SKETCH PLAT DEPARTMENT OF TRANSPORTATION 3RD ADDITION

DEPARTMENT OF TRANSPORTATION
AND CITY OF WICHITA

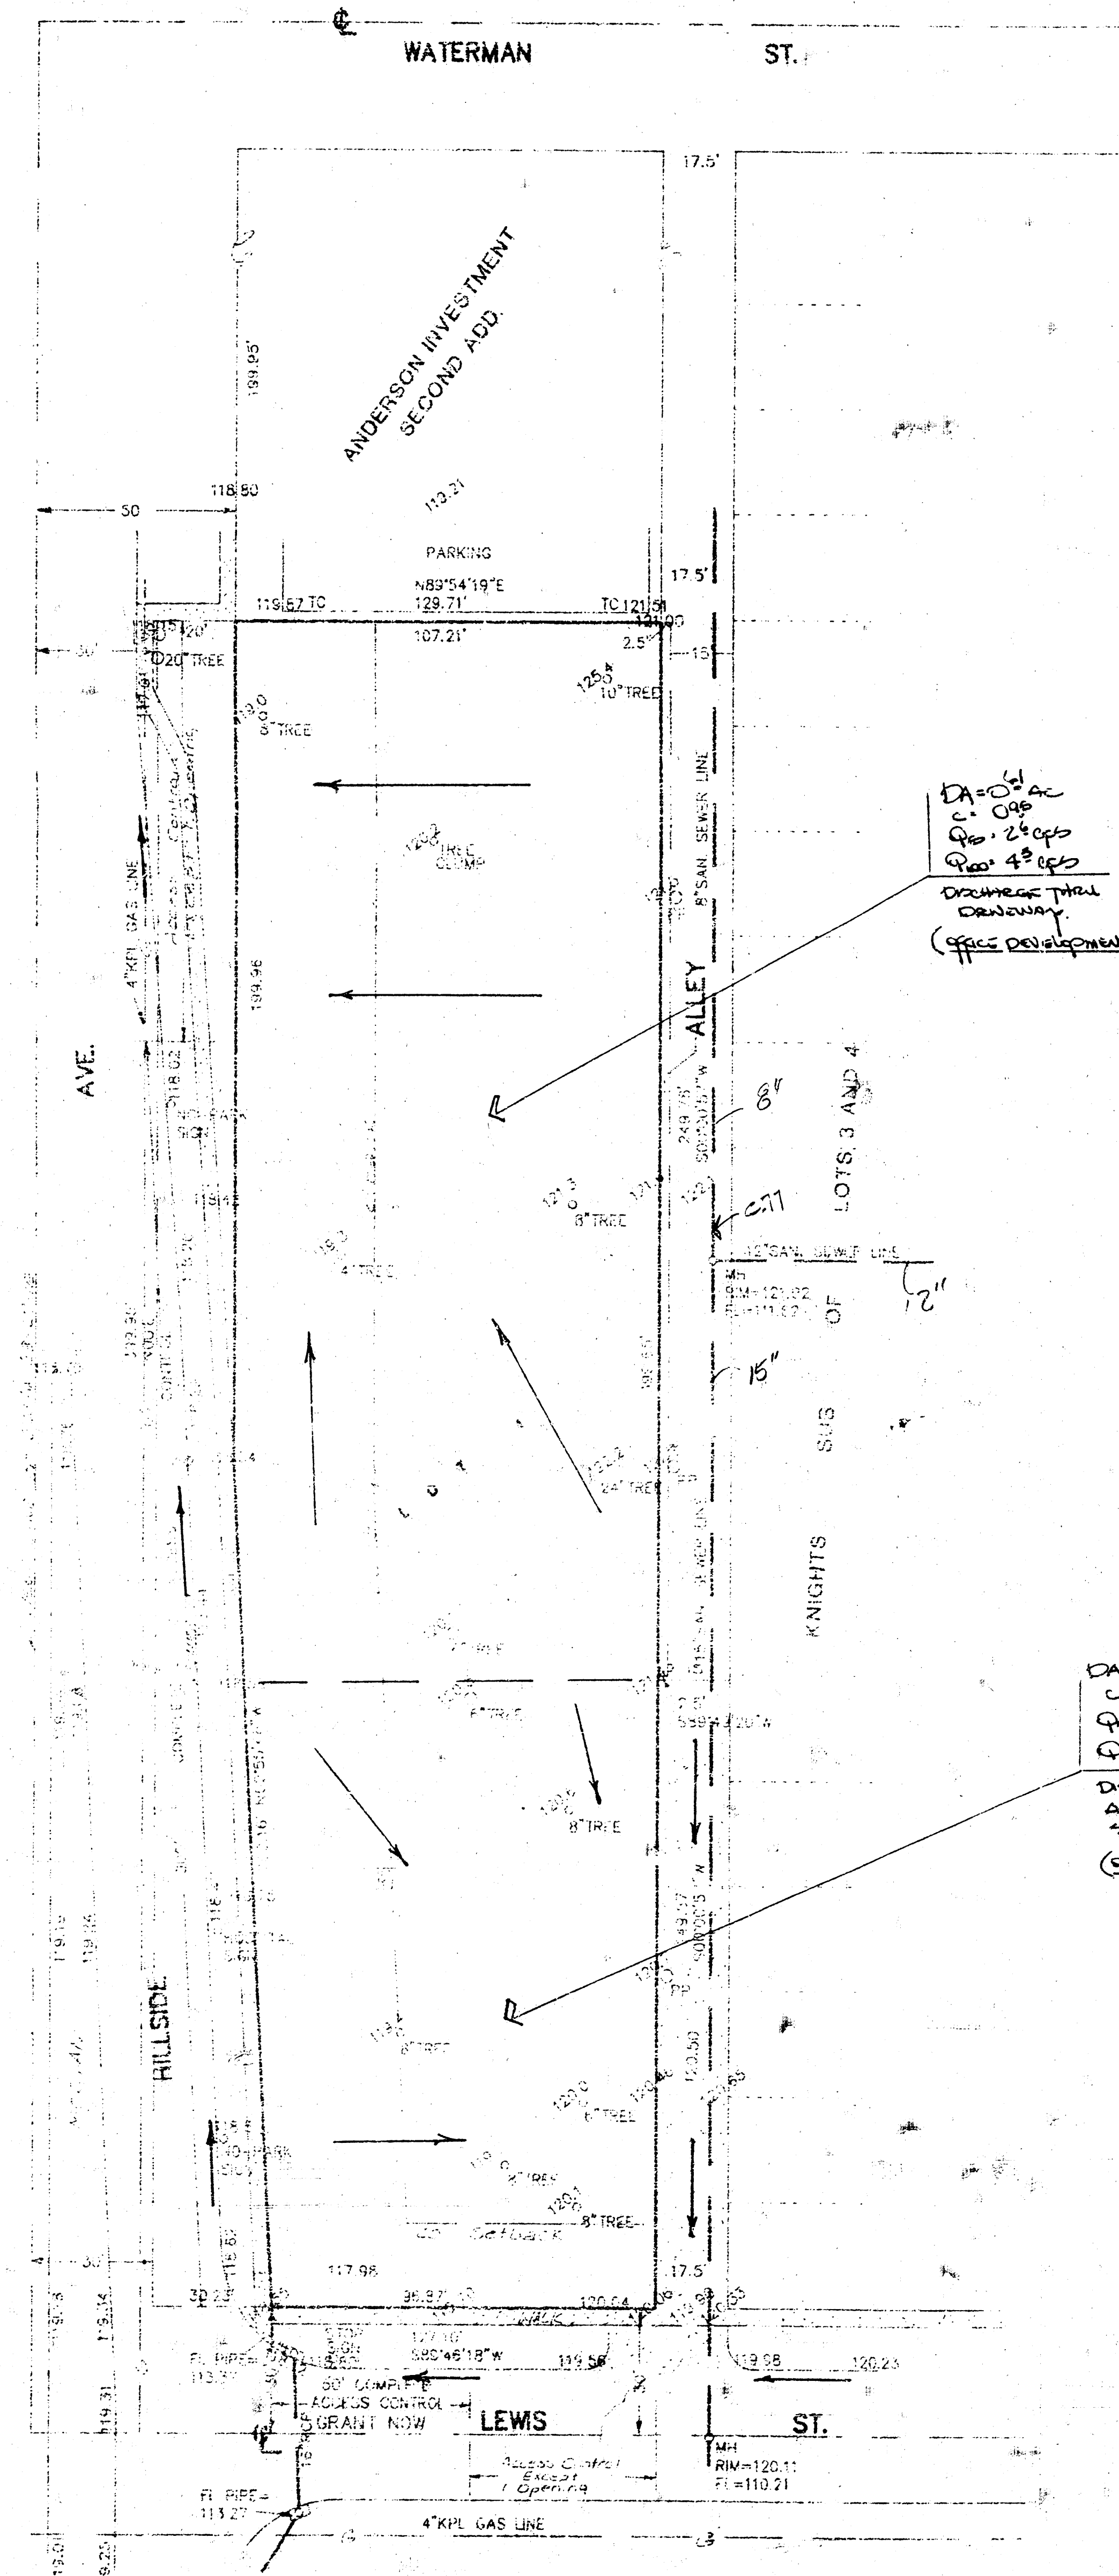
Prove existing storm
sewer can take
all this water & tell
what existing runoff
to to SS is.
And prove won't flood
street
Paved Alley? Brent
